**PALO VERDE COMMUNITY COLLEGE  
NEEDLES CENTER (CLAYPOOL BUILDING)  
MEZZANINE PROJECT**

**BID NO. 2020-01**

**ADDENDUM NO. 1**

**October 23, 2020**

**ACCESSIBLE RESTROOM PATH** ②  
1/4" = 1'-0" N

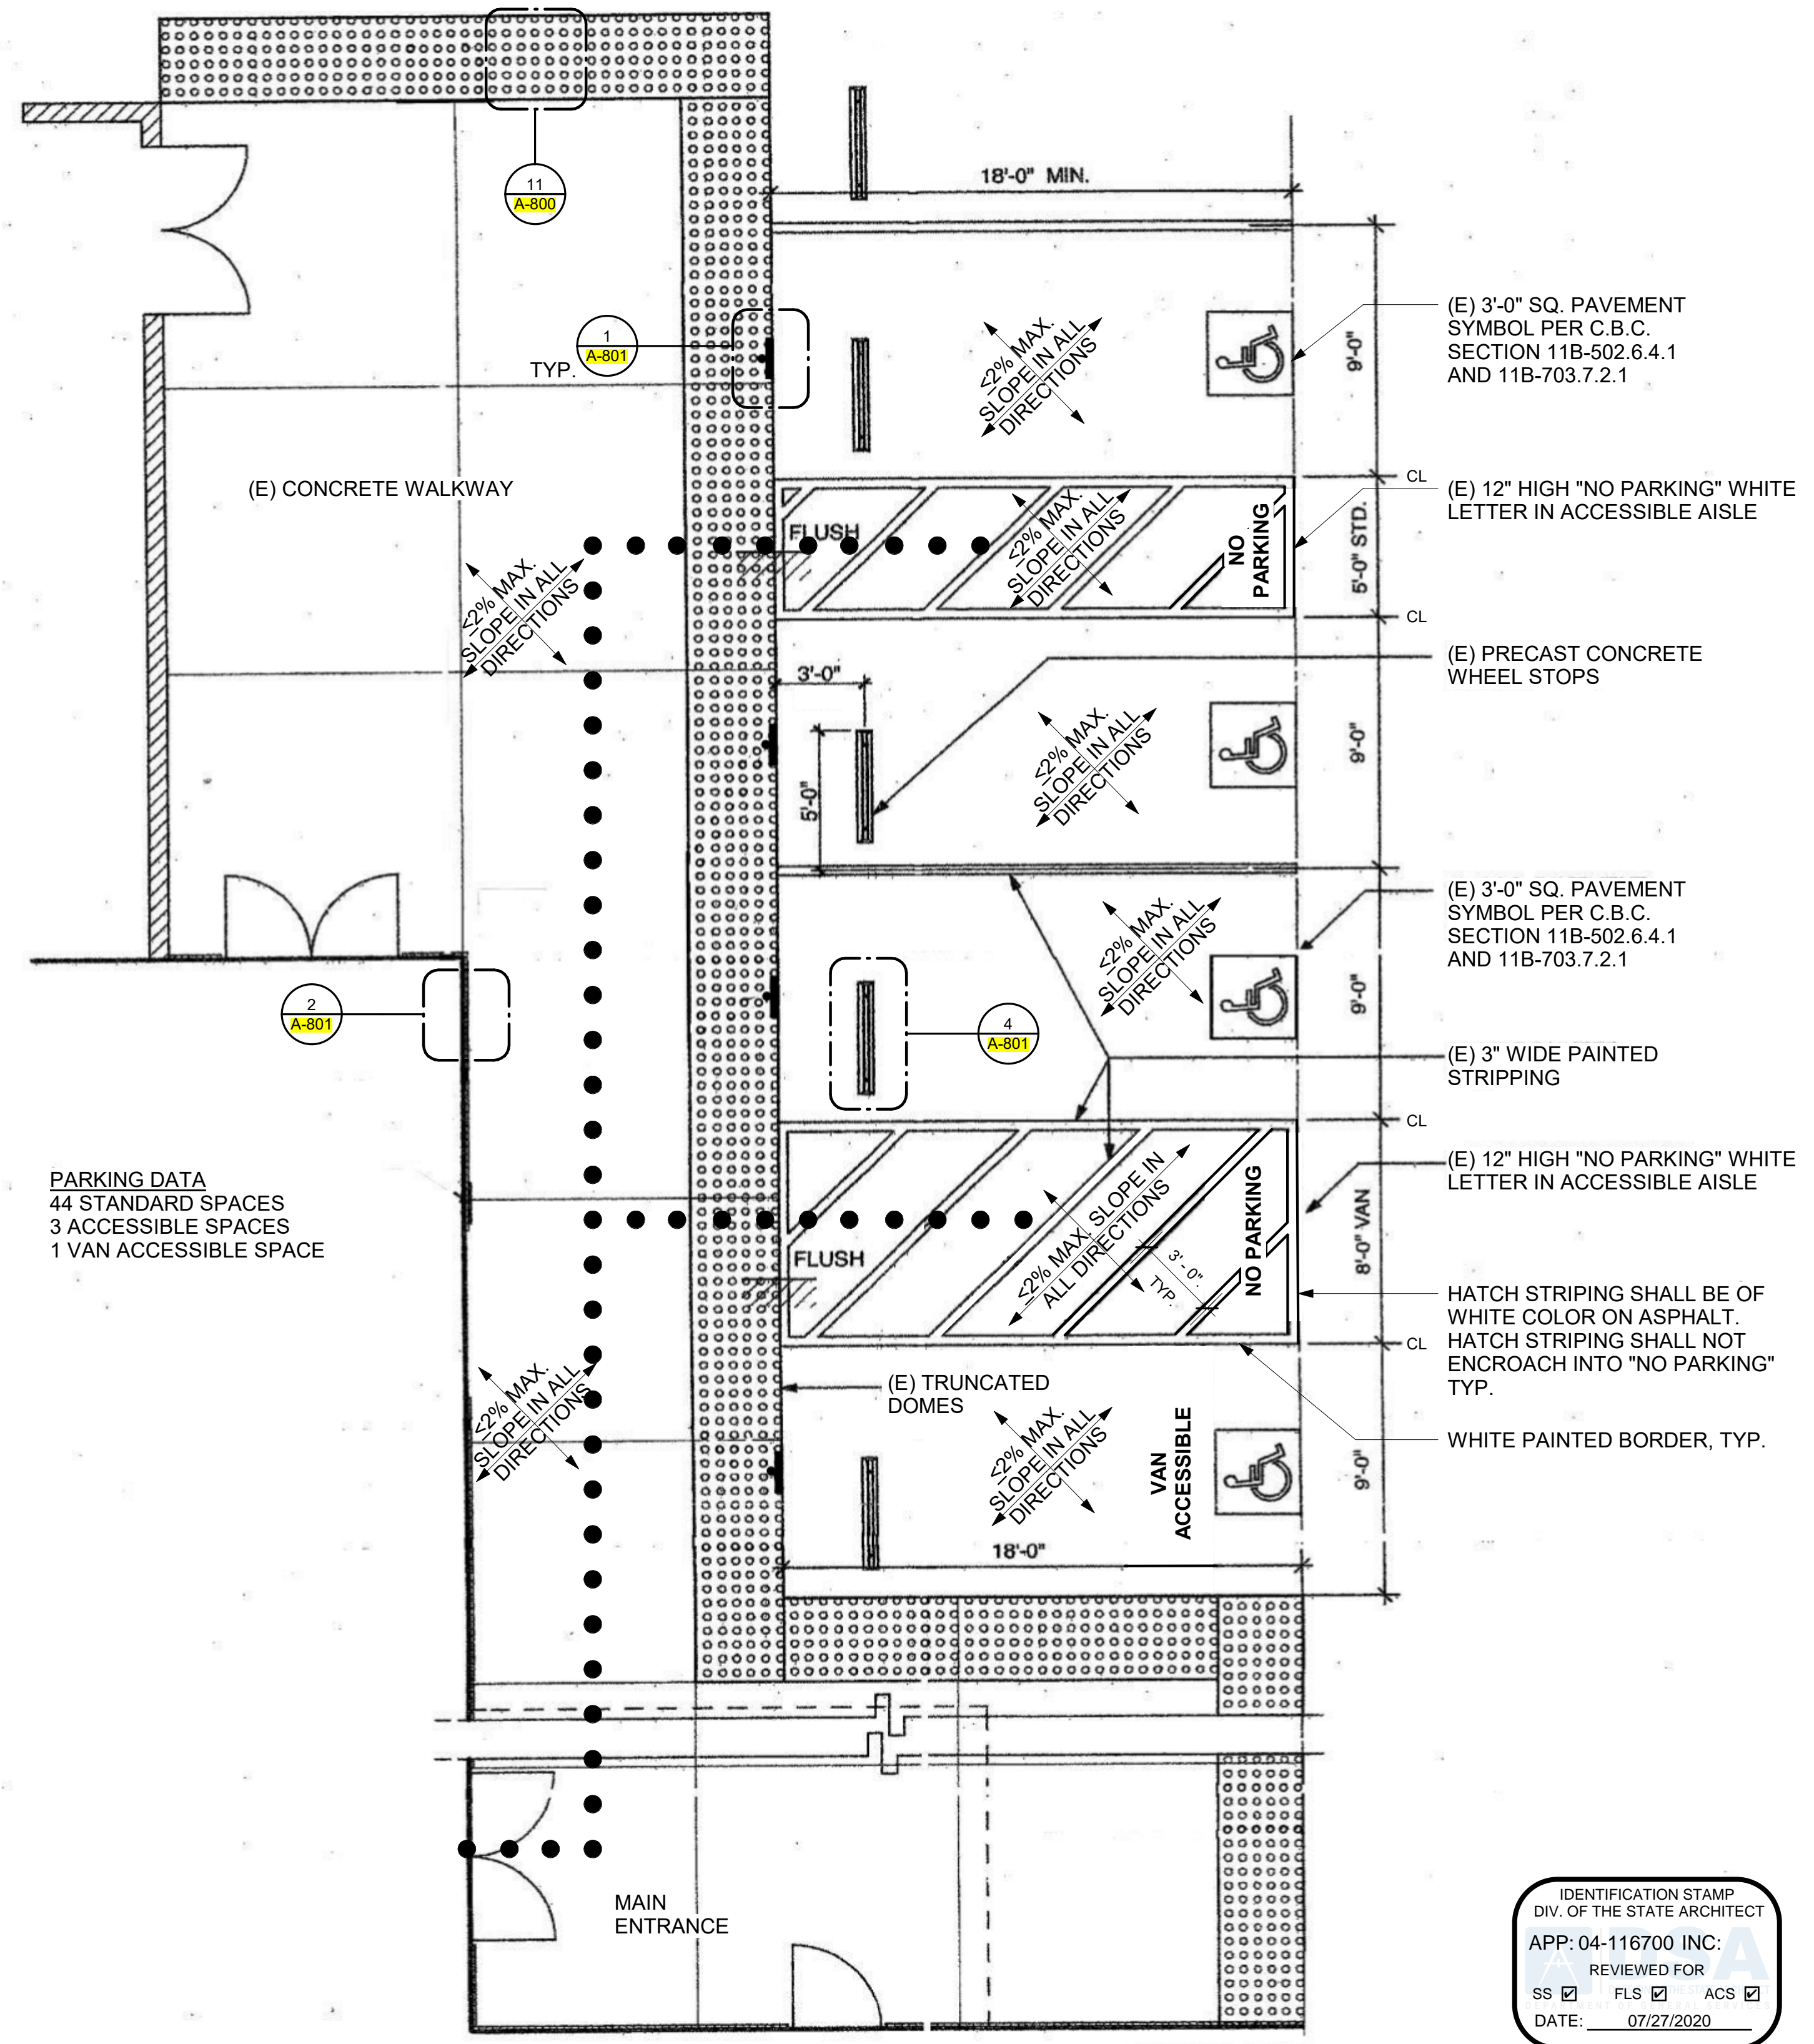
1. Sheet G-004: Detail #2, Accessible Restroom Path – Keynote at Men's RR has been revised from 2 to 1
2. Sheet A-201: Keynote #26 has been revised
3. Sheet A-201: Keynote #38 has been added
4. Sheet A-201: Keynote #39 has been added
5. Sheet A-201: A new built-in bench has been added to Room 206 Student Lounge
6. Sheet A-201: A new note has been added to patch the hole in the concrete floor
7. Sheet A-201: Note added to provide dust & pollution control during construction
8. Sheet A-203: Keynote #12 has been added and ceilings in Rooms 203, 204 & 207 are now indicated to have new suspended gyp board ceiling
9. Sheet A-802: Detail #10 has been added
10. Sheet A-802: Details #11 has been added
11. Sheet S1.0: New furring wall has been added to Rooms 203, 204 & 207

**A-201**

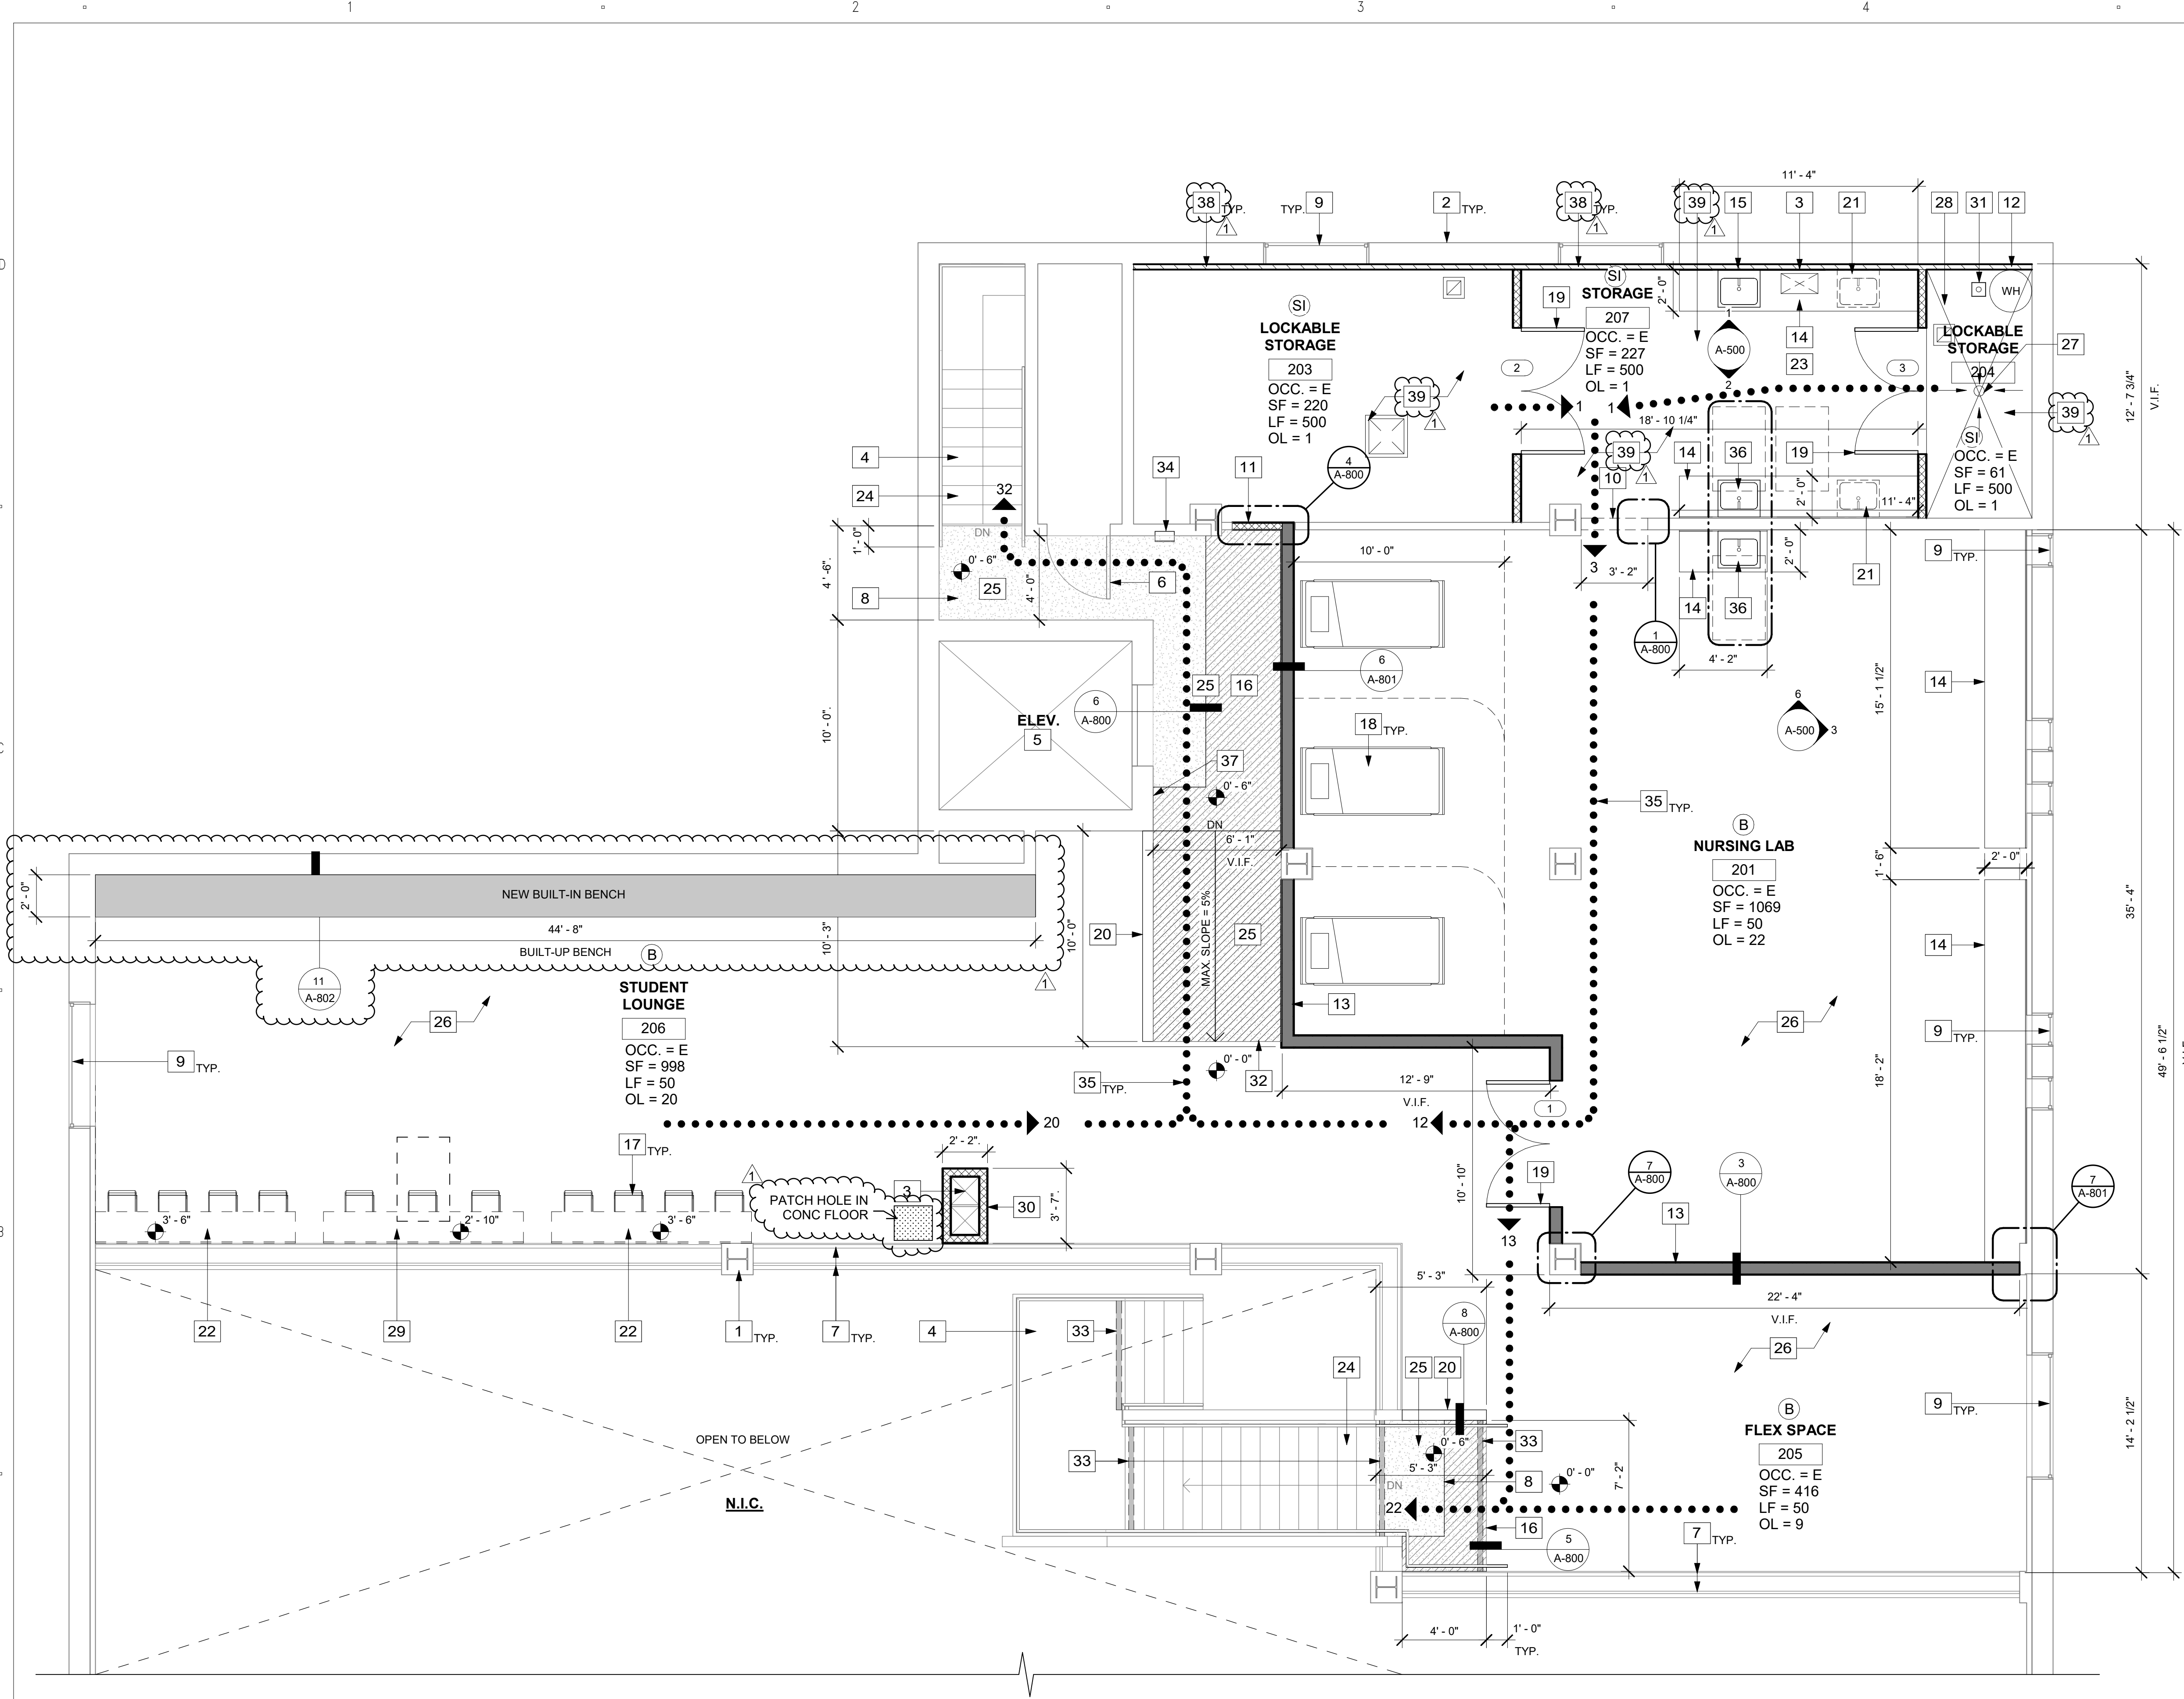
RFI 2 Question: Note 26 on A-201 states existing flooring to remain in the student lounge (Room 206), Nursing Lab (Room 201), and Flex Space (Room 205). The existing flooring is bare concrete. We noticed there is a carpet line item on the engineers estimate and there is carpet tile in the spec book, we clearly see the area at the elevator and stair landing are raised with carpet. Please advise what material is to be used in these rooms.

RFI 3 Question: Lockable Storage (Room 203), Storage (Room 207), and Lockable Storage (Room 204) do not appear for any flooring called out on the prints. Please advise what type of flooring goes in those rooms as well.

RFI 4 Question: Lockable Storage (Room 203), Storage Room (Room 207), and Lockable Storage (Room 204) have a steel plate floor. There are bolts protruding through the floor, approx.  $\frac{3}{4}$ ". It is our understanding that these bolts cannot be removed. How is a floor covering being installed over these bolts?

RFI 2 Response: Note 26 on A-201 now reads “NEW CARPET TILES PER SPECS” Carpet and new vinyl base shall be provided in Rooms 201, 205 and 206. See revised Sheet A-201.

RFI 3 Response: Rooms 203, 207 and 204 shall receive resilient flooring with vinyl base per specifications. See revised Sheet A-201.

RFI 4 Response: Rooms 203, 204 and 207 shall receive a 1" fluid applied concrete topping (“Commercial Topping” by Maxxon Corporation, or approved equal, see attached). Refer to revised Sheet A-201.

- 36 NEW ACCESSIBLE SINK
- 37 PROVIDE TWO-WAY COMMUNICATION SYSTEM WITH BOTH AUDIBLE AND VISIBLE SIGNALS PER CBC SECTION 1009.8, SEE 10/A-803
- 38 REMOVE (E) PLASTER AND/OR GYP BOARD FROM EXTERIOR CONC WALL. PROVIDE NEW FURRED WALL PER STRUCTURAL SHEET S2.0

- 39 PROVIDE 1" CONCRETE TOPPING AND NEW VINYL FLOORING AND BASE IN ROOMS 203, 204 & 207. "COMMERCIAL TOPPING" BY MAXXON CORPORATION, OR APPROVED EQUAL
